**U.S. ROUTE 5
HARTFORD AVENUE**

ADDENDUM #1: REVISED APRIL 18, 2007

PROJECT NAME:	HARTFORD	PLOT DATE:	4/18/2007
PROJECT NUMBER:	RS 0113(40)	DRAWN BY:	E. ATKINS
FILE NAME:	z86c027xsl.dgn	CHECKED BY:	K. ISHIKURA
PROJECT LEADER:	KEN UPMAL	SHEET	199 OF 239
DESIGNED BY:	E. ATKINS

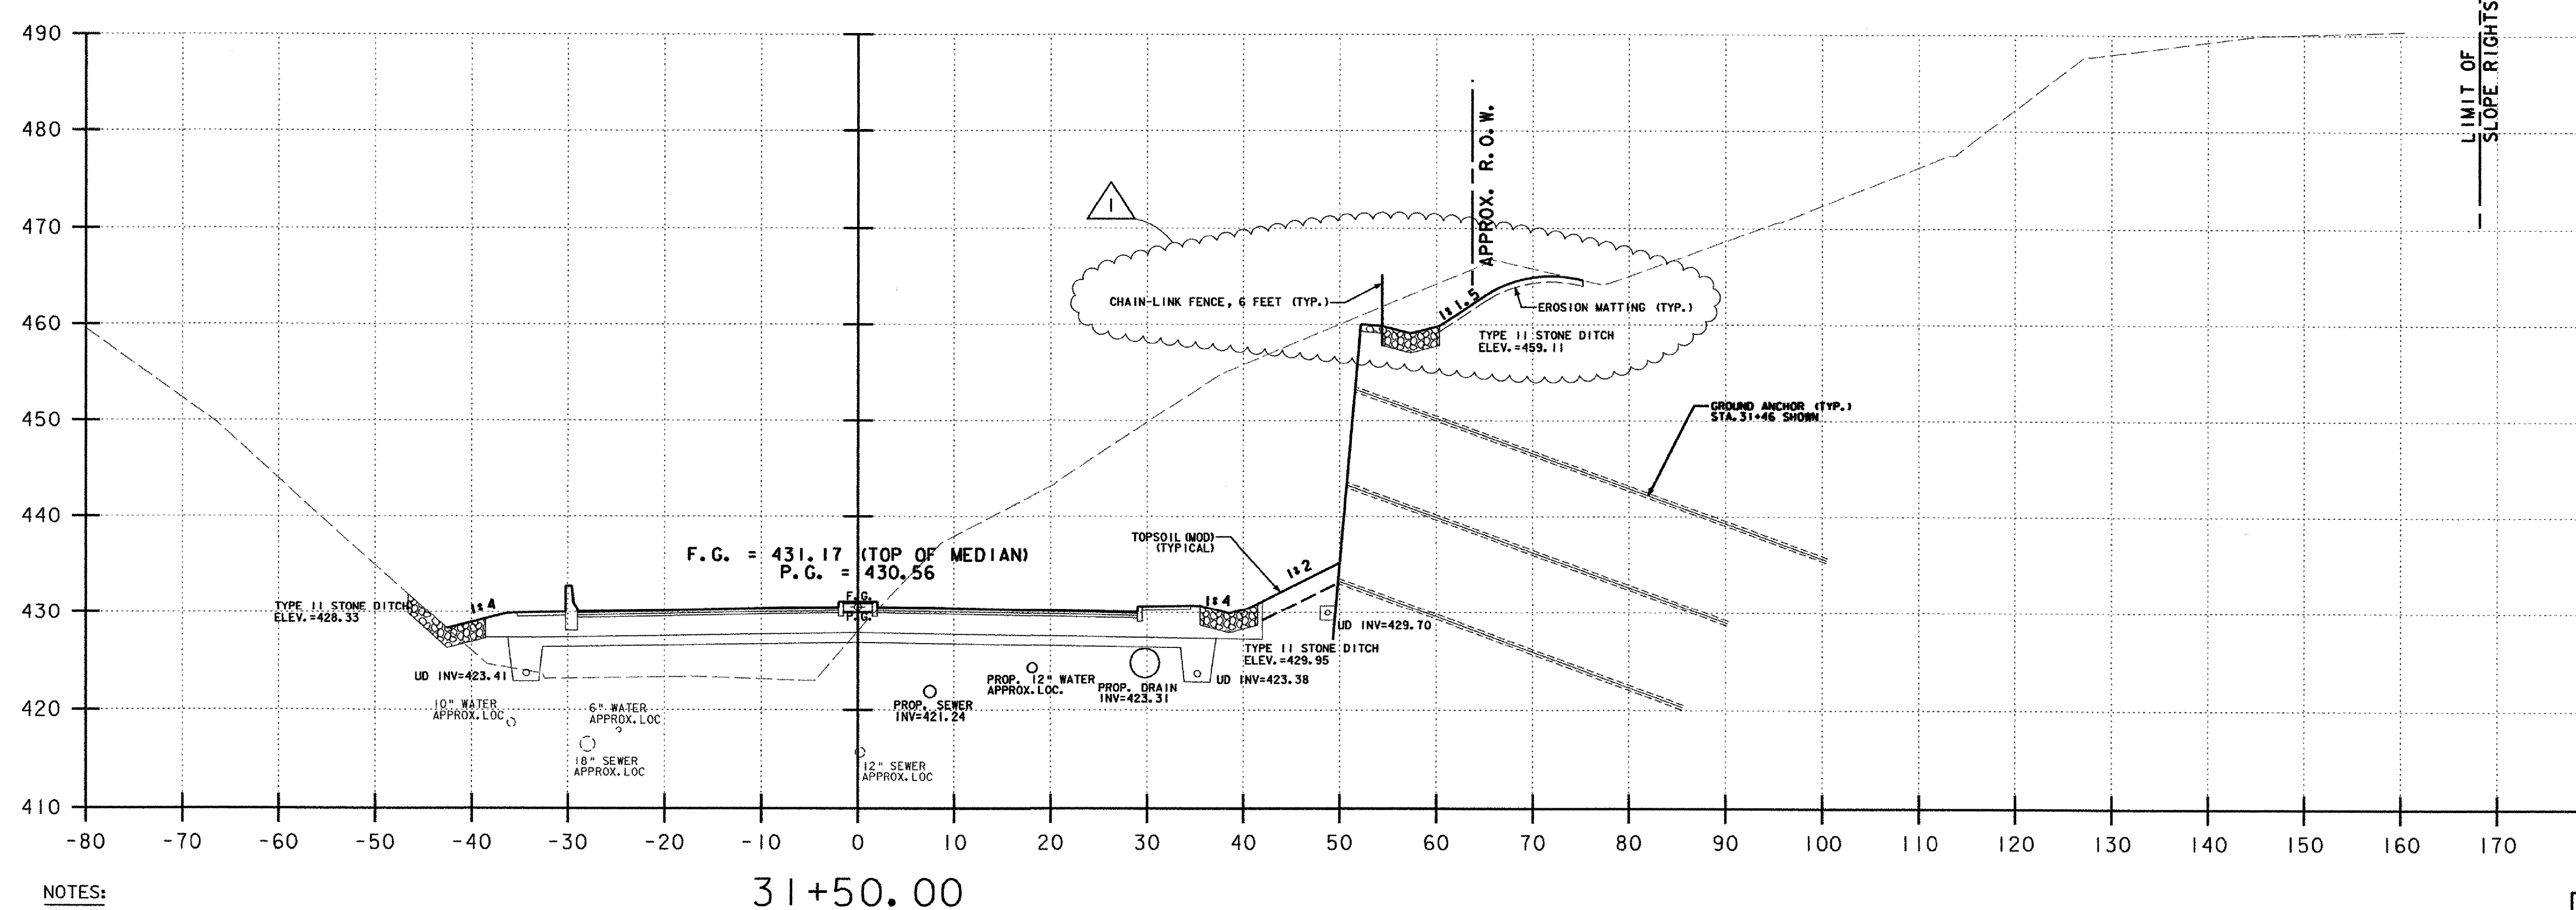
SEE VALUE ENGINEERING
RETAINING WALL
